CITY OF BELLEVUE, IDAHO
Planning and Zoning Commission
Monday, March 3, 2025, 5:30 PM
115 Pine Street, Bellevue, Idaho 83313

a. LLA-25-01 – TBD Lewis Lane – Judy & Keith Meyers – Continued from February 18, 2025

An application for a lot line adjustment for Lots 1-6, Block 96 of the Bellevue Townsite Original Plat. The proposed lot line adjustment will reconfigure the existing six (6) parcels into three (3) parcels and include a request for waivers from code requirements.

A LOT LINE SHIFT PLAT SHOWING
LOTS 1A, 2A, & 3A, BLOCK 96, BELLEVUE TOWNSITE
AUGUST 2024

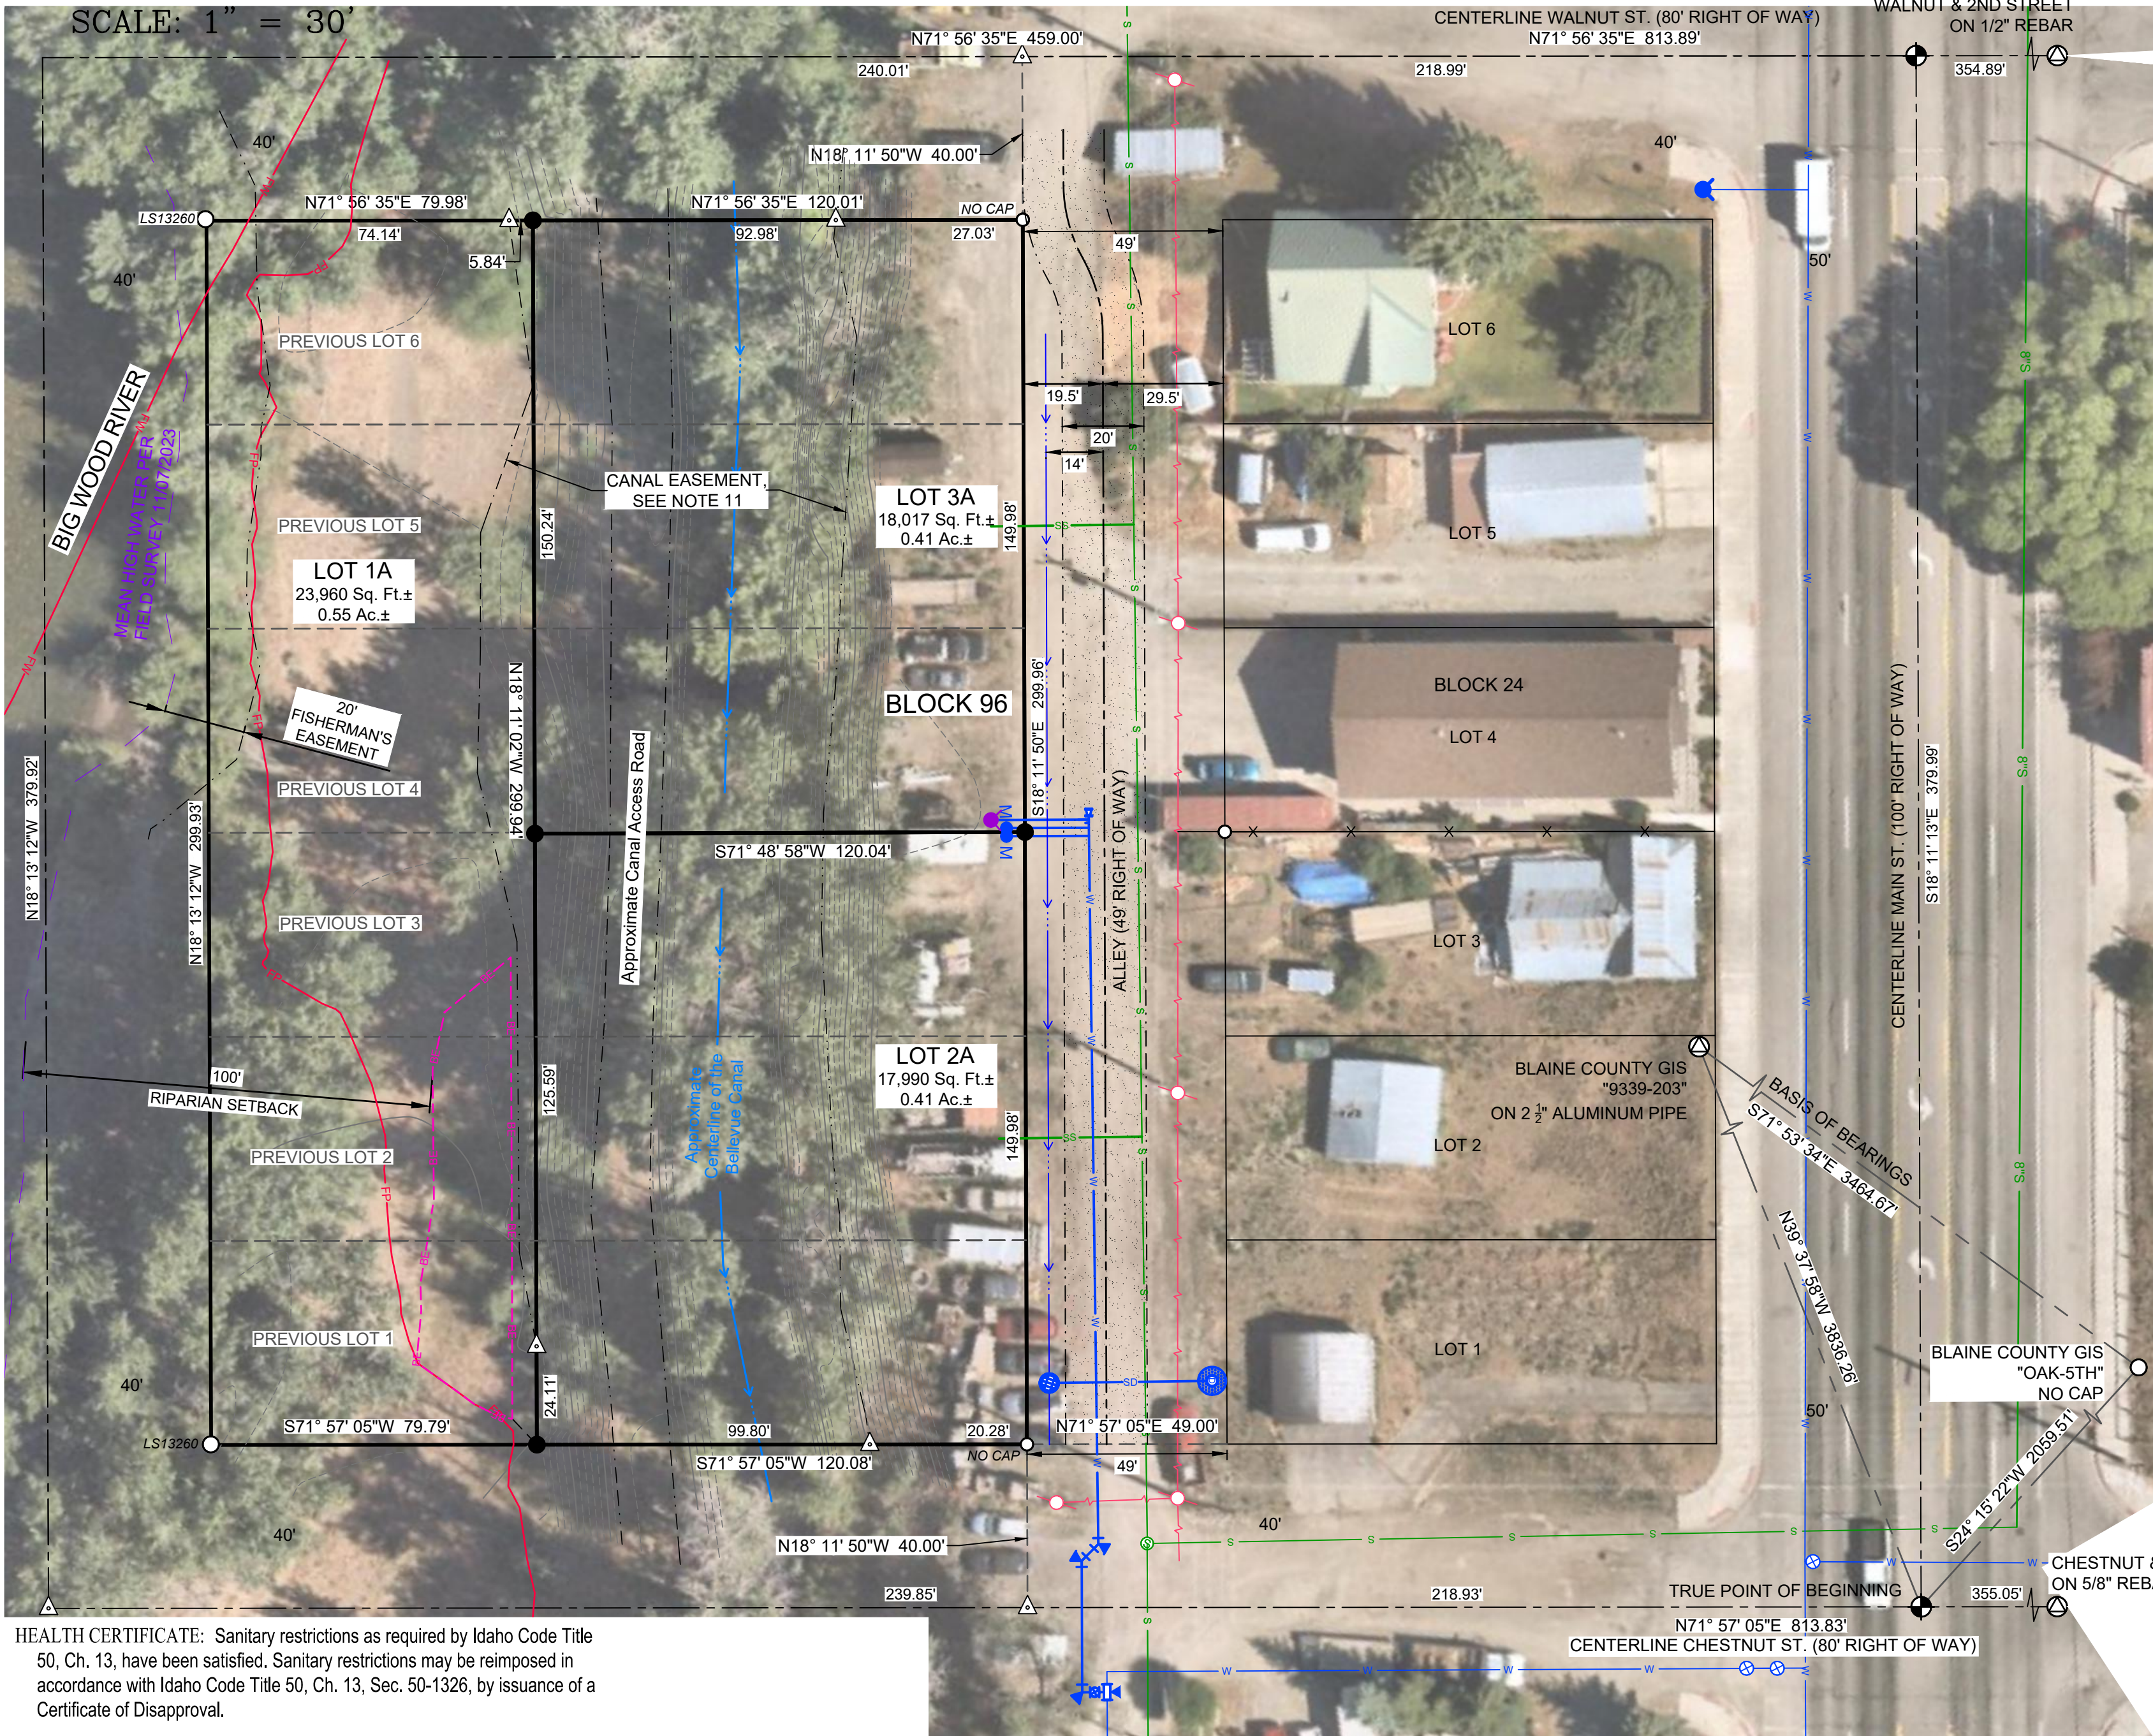
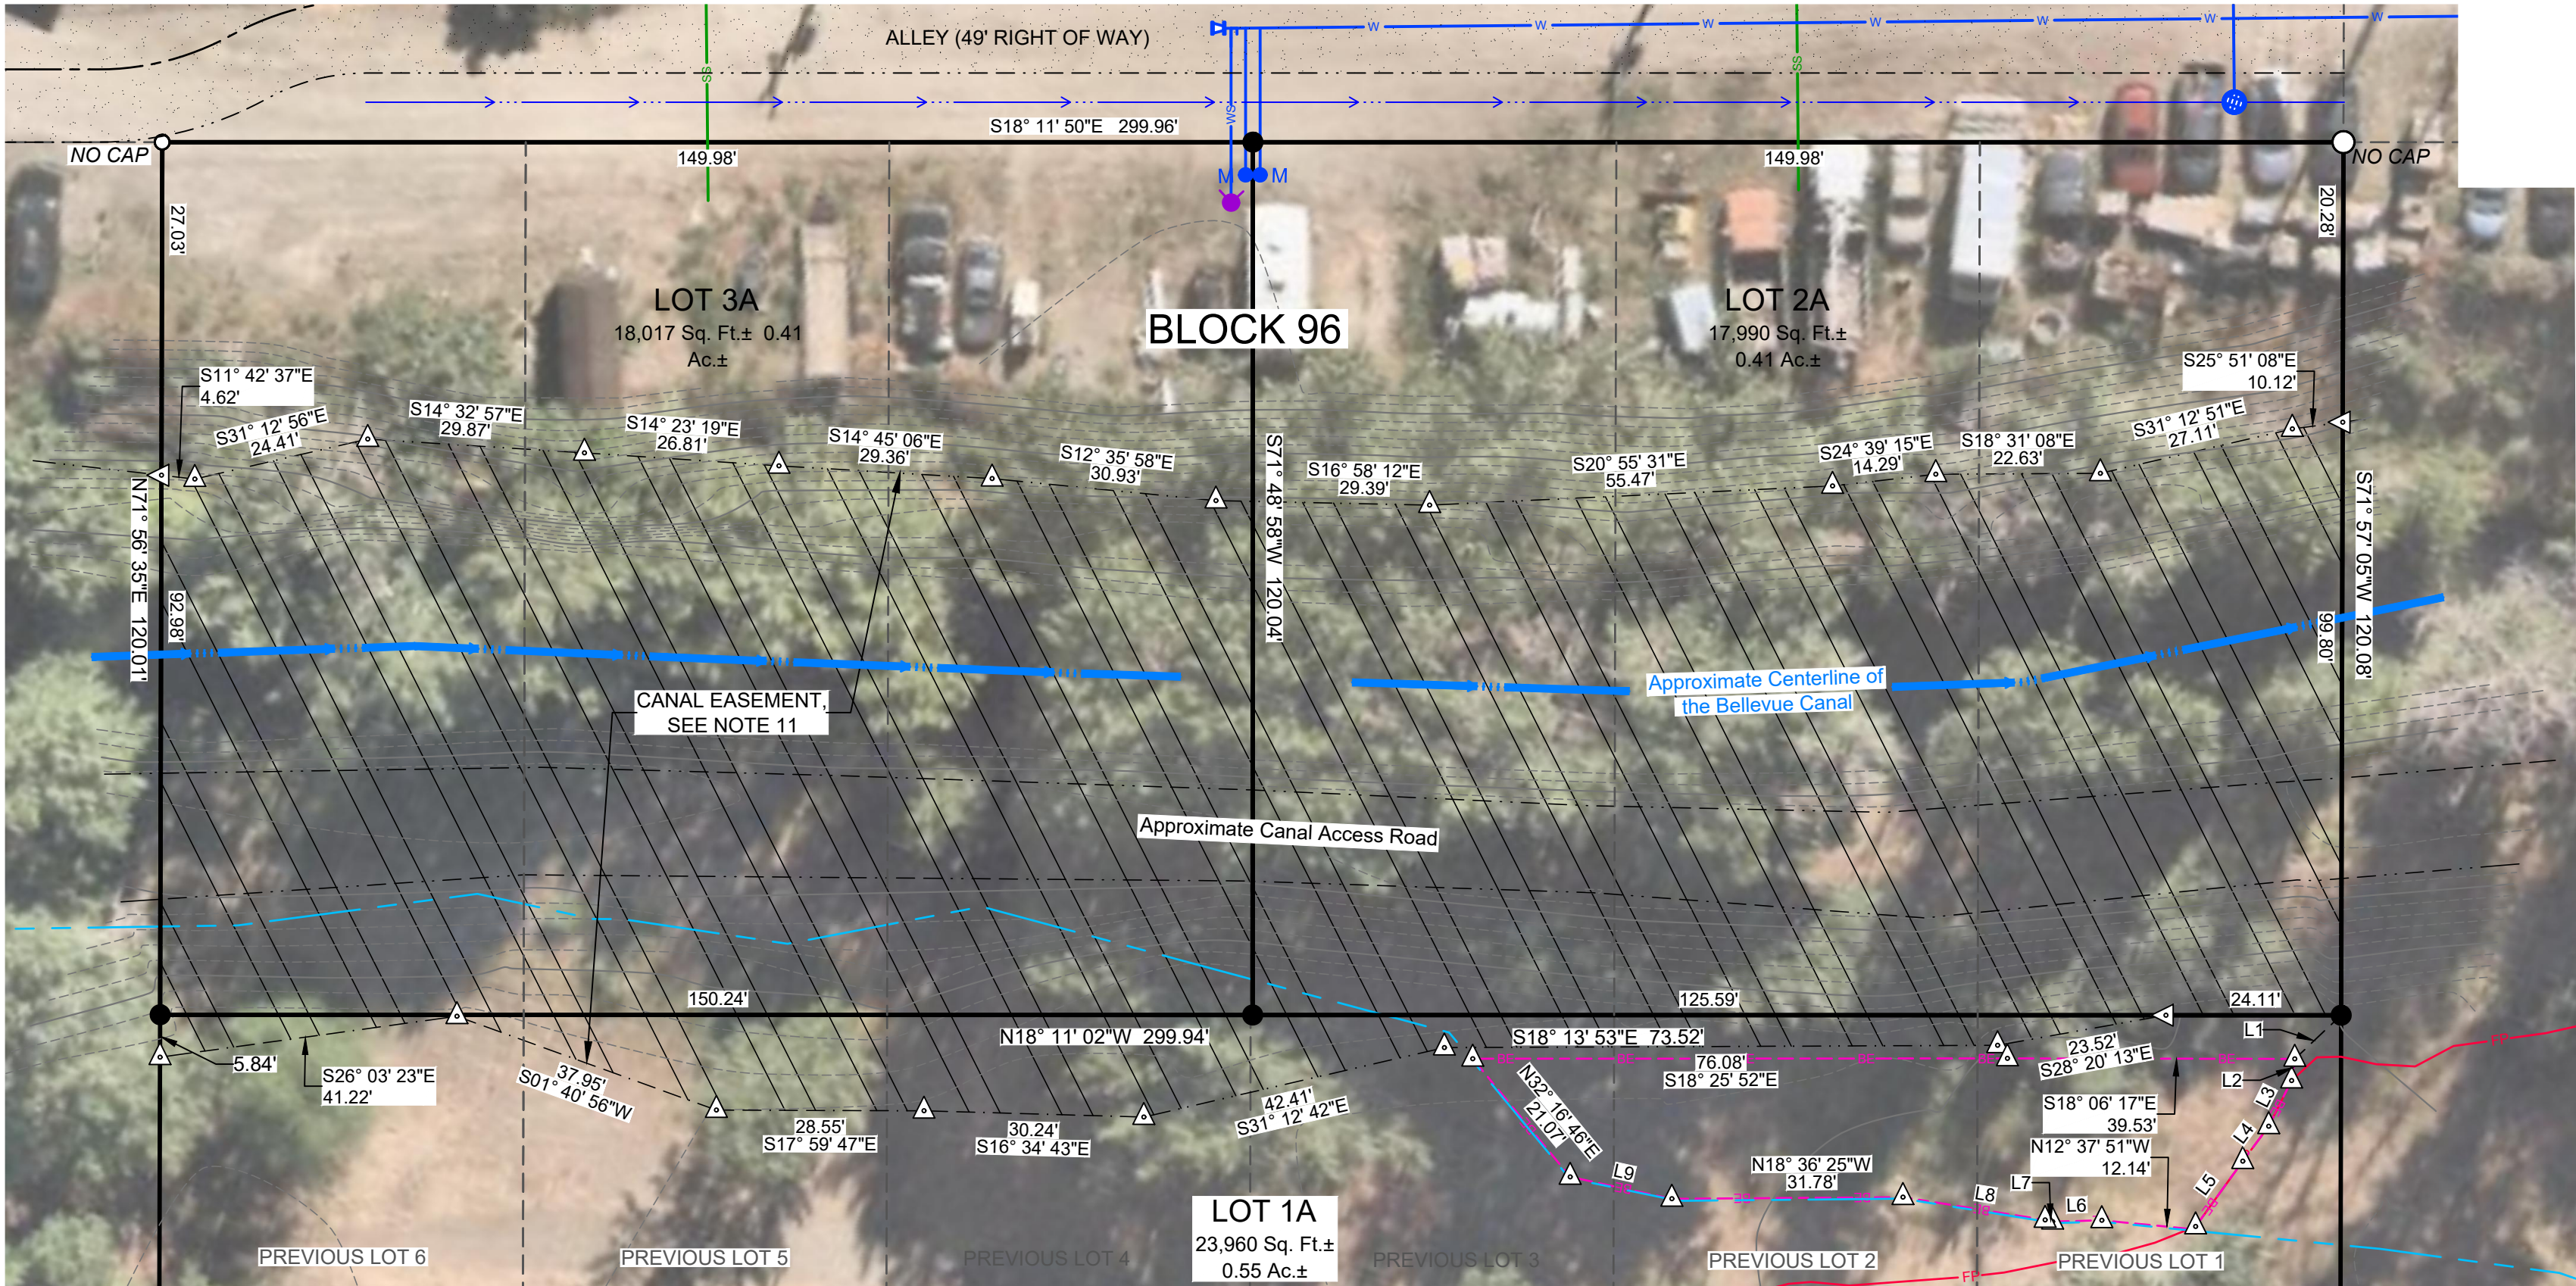
“Corner lots shall show BE’s in accordance with 11.4.6.C on the final plat.”

The applicant has provided a justification for an alternate analysis of Bellevue City Code Section 11-4-6(C), and correctly asserted that questions regarding the interpretation of Title 11 of Bellevue City Code are to be referred to Council for a determination (Bellevue City Code Section 11-6-1). The Code section in question is as follows:

- 2. In order to be compliant with the Subdivision Design and Improvement Requirements for Lots established by Bellevue City Code Section 11-4-6(G), “Every lot in a subdivision shall have a minimum of twenty feet (20’) of frontage on a dedicated public or private street.” (Emphasis added). If we were to accept the applicant’s justification that the right of way to the east of the subject property is not a “street” but an “alley,” the street frontage of the subject property is limited to the undeveloped portions of the Walnut and Chestnut Street rights-of-way to the north and south, respectively, and the unnamed, undeveloped right-of-way to the west. Each of the proposed lots has more than twenty feet (20’) of frontage along the rights-of-way, however without providing vehicular and pedestrian access to the adjacent property, the right-of-way does not meet the definition of “street” from Bellevue City Code Section 11-2-1. If the right-of-way to the east of the subject property is not to be considered a street, the proposed configuration*

fails to provide any justification for this claim. Encroachments into right-of-way, including power transmission lines are very common within the City of Bellevue. As such, it is Staff's opinion that no "special physical characteristics or conditions" exist that would make literal enforcement (improvement of right-of-way to City standards) an undue hardship. Staff is not supportive of this waiver request.

3. Prior to the submittal of a final plat application, the applicant shall provide a revised preliminary plat identifying building envelopes for all corner lots in accordance with Bellevue City Code Section 11-4-6(C).

5. Prior to the submittal of a final plat application, the applicant shall submit a revised preliminary plat identifying an easement for the Bellevue Canal District and documentation that the proposed easement has been reviewed and accepted by the Bellevue Canal District.

6. Prior to the submittal of a final plat application, the applicant shall submit a revised preliminary plat identifying the ordinary high water mark and a twenty foot (20') wide fisherman's easement along the landward side of the ordinary high water mark.
7. No construction or grading shall occur until the Bellevue City Engineer has reviewed and approved the construction drawings.

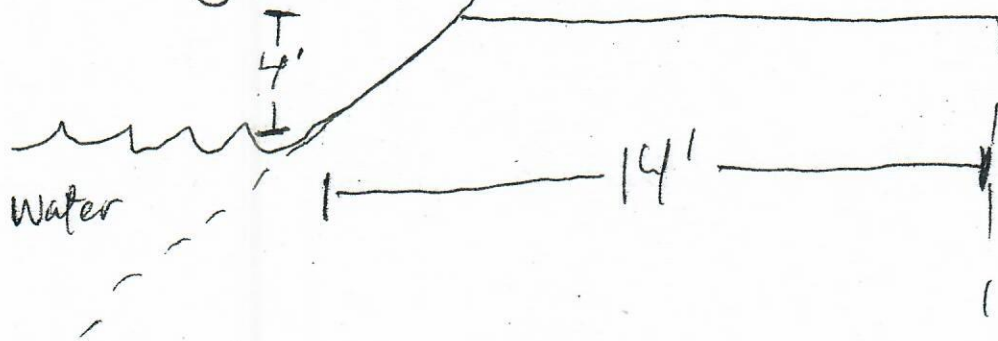
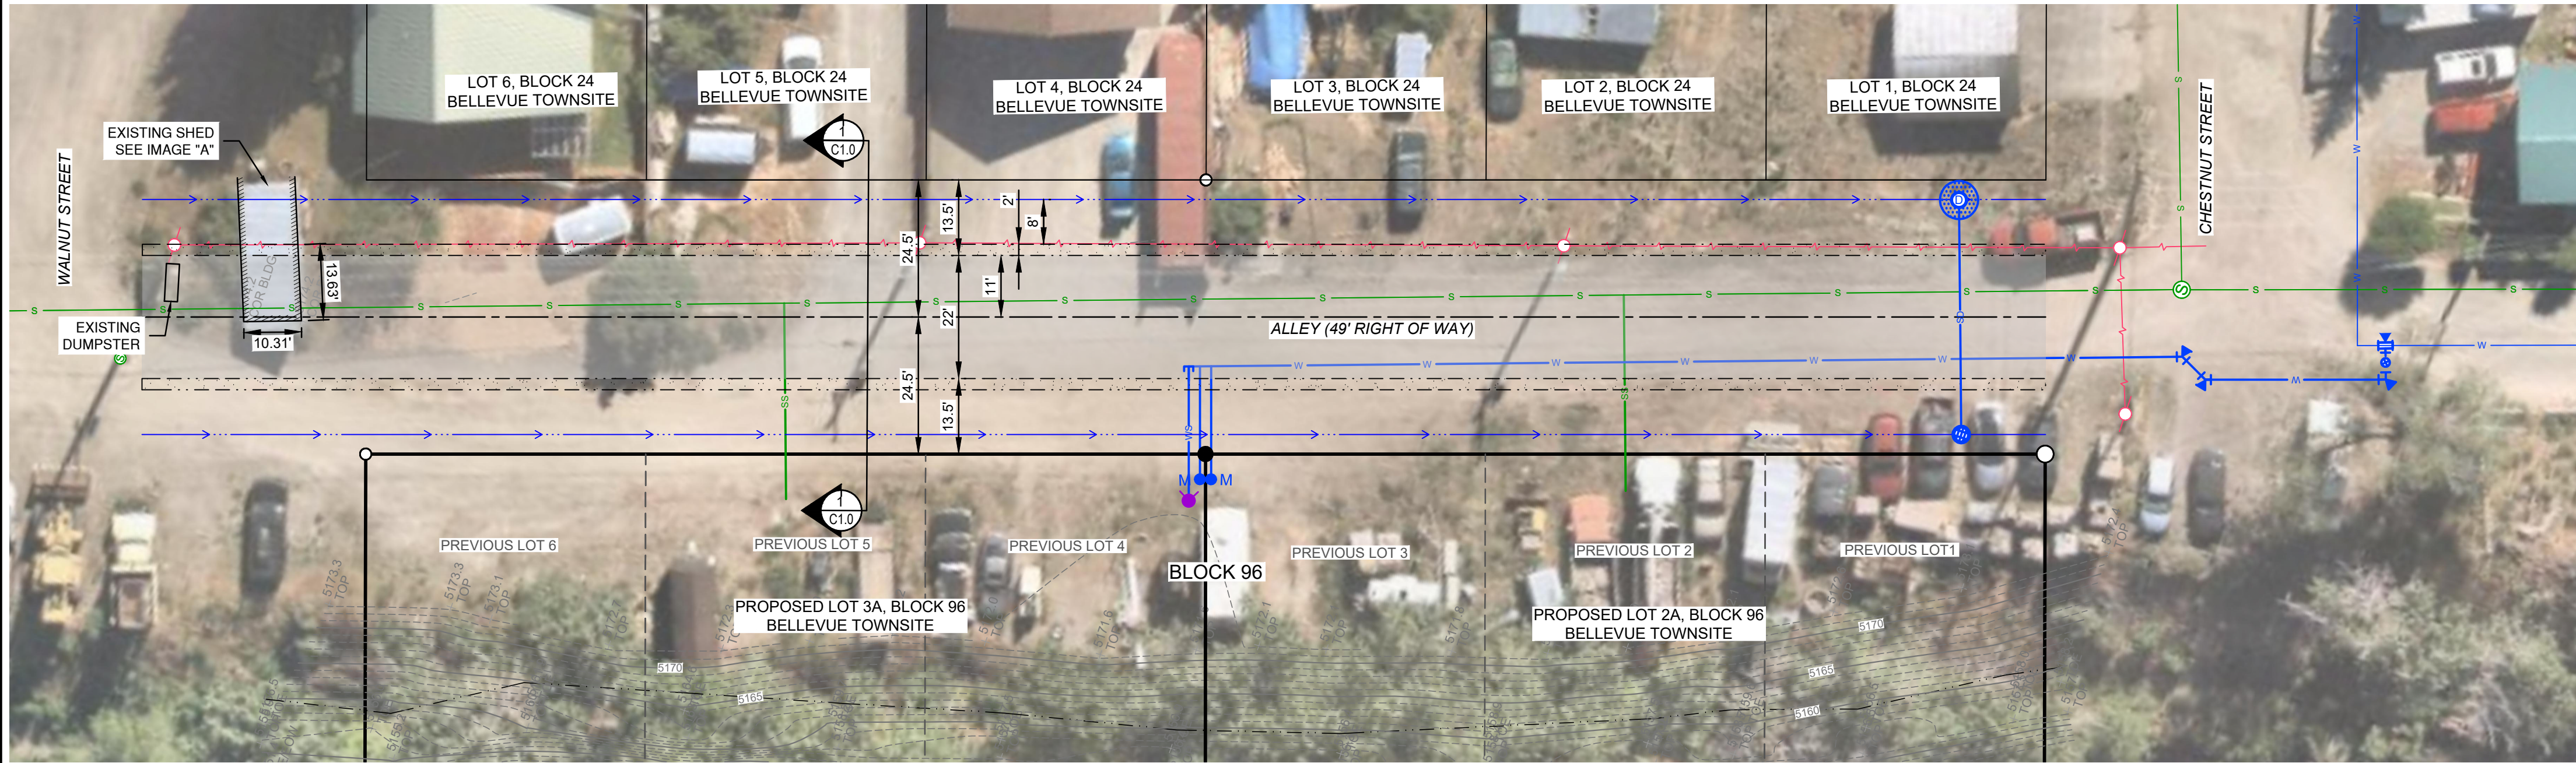
District will give up existing bank
if a wall is installed 14' from
the high water line and to a
depth well below the high water
line. In addition a ~~terrace~~
terrace must be constructed
that is 4 feet above the
high water line, leaving
any existing trees that
are at waters
edge.

Keith, This is
the arrangement
that both Districts
said they would
sign. Let me know if
this would work for
you and I can get
a final agreement
properly signed
